MASTER DEVELOPMENT PLAN NO. 821 PUD PLAN NO. 05-037

STONEWALL ESTATES
PLANNED UNIT DEVELOPMENT (PUD) PLAN

A memo from the
CITY of SAN ANTONIO
Planning Department
Master Development

SUBJECT: # 05-037

JOB NO. 6139-00
DATE: SEPTEMBER 2005
DESIGNER: BAC
CHECKED: SLW, DRAWN: AKP
SHEET: C1.00

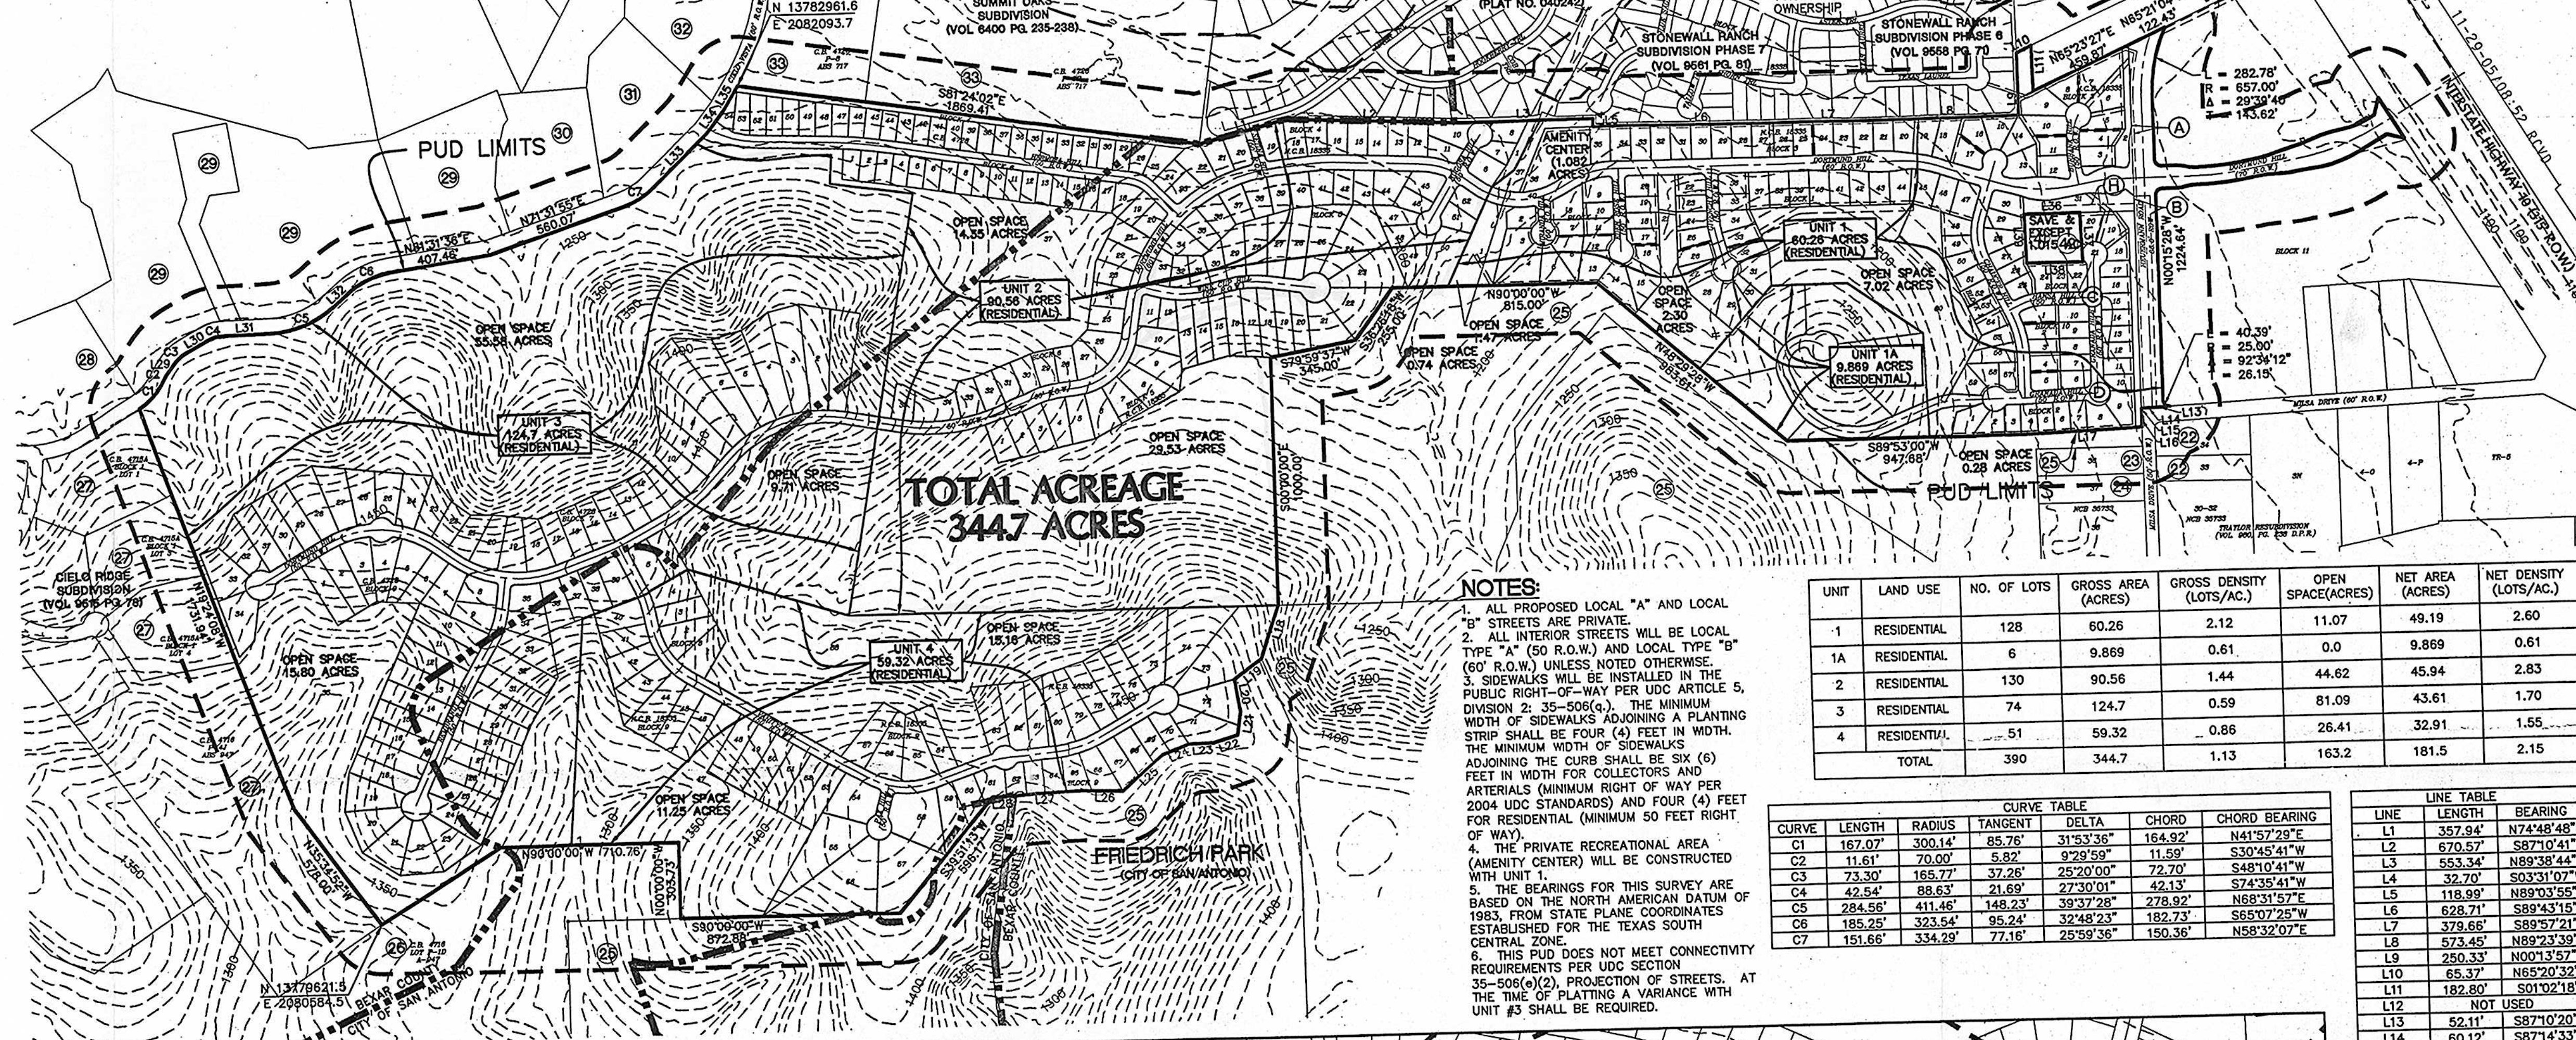
- Any change in location of roads, lots, drainage easements, or drainage rights-of-way during platting of units will require an amendment to the PUD Plan.

- 100 Year Flood Plain and buffering to be shown (if applicable)
- Sensitive Recharge Features and buffering to be shown (if applicable)
- Category Letter of all Site Specific Plats (Category 2 and 3 require Aquifer Protection Plan)

The DSD – Streets Division has reviewed the Stonewall Estates PUD (time-stamped October 6, 2005). The analysis indicates compliance with the UDC.

- For cul-de-sacs greater than 500 ft long, pavement widths are required to be 30 ft wide, with 50 ft radius pavement turnarounds, to be reviewed during platting.
- Grades are shown to be in excess of the 12 and 15% limits of UDC 35-506(d)(3). Grade and K-value requirements of the UDC shall be complied with during platting.
- Blocks lengths shown are greater than that allowed by UDC 35-515(b)(3). Block length standards shall be reviewed at time of platting.
- All access roadways shall provide clear sight distance on all existing and proposed roadways in accordance to UDC 35-506(d)(5). All signage, landscaping, and improvements shall be selected and located so as to not block these clear sight distance areas.

- **Milsa Drive/Heuermann Road** - Dedicate 86-feet of ROW and construct a 4-lane divided roadway (Secondary Arterial Type A). The limits of construction shall be extended through the Stonewall Estates development as shown on the City of San Antonio Major Thoroughfare Plan.

- **Milsa Drive/Heuermann Road and Dortmund Hill** - The developer shall be responsible for upgrading capacity, which includes a southbound right-turn deceleration lane with a storage lane and bay taper as it relates to the submitted TIA traffic counts, (Uniform Development Code (UDC) - 35-502 (a)(7), subsection C.
 - Clear sight distances shall be provided at each roadway intersection to allow adequate, obstruction-free viewing distances for approaching traffic. All signage, landscaping and improvements should be selected and located so as to not obscure the minimum intersection visibility.

- The internal roadway, Dortmund Hill should be constructed as a Local Type 'B' – from Heuermann Road to approximately 800 feet west of the Wine Cup Hill. From this point on, a Local Type 'A' may be constructed. This recommendation is based on the current planned land use and PUD Plan.
- All Roadways shall conform to UDC 35-506 (c), (1), Table 506-1: Functional Classification System Description.
- All commercial driveways for this project shall comply with UDC 35-506, (r) Access and Driveways.
- Provide clear sight distance at each roadway to provide adequate distance for obstruction free viewing distances for approaching traffic. All signage, landscaping and improvements should be selected and located so as to not block these clear sight distance areas.

Heuermann Road and Babcock Road have undeveloped land along its length to develop into a heavily traveled corridor. With the completion of the Dominion Overpass Project, the commercial property for this project will be developed at a rapid pace. TIA Reviews has concerns about the intersection of proposed ***Milsa Drive/Heuermann Road and Dortmund Hill*** being in close proximity to the future interchange at Dominion Drive. TIA Reviews recommends that this intersection be located a minimum of 1300 feet from the proposed interchange. The City of San Antonio and Cielo Vista Associates entered into a Road Construction and Dedication Agreement by Ordinance 74217 of August 29, 1991. In this agreement, right of way has been dedicated and approved for the conditions that TIA Reviews has concerns about. A traffic signal will not be allowed at this location due to the close proximity of the interchange.
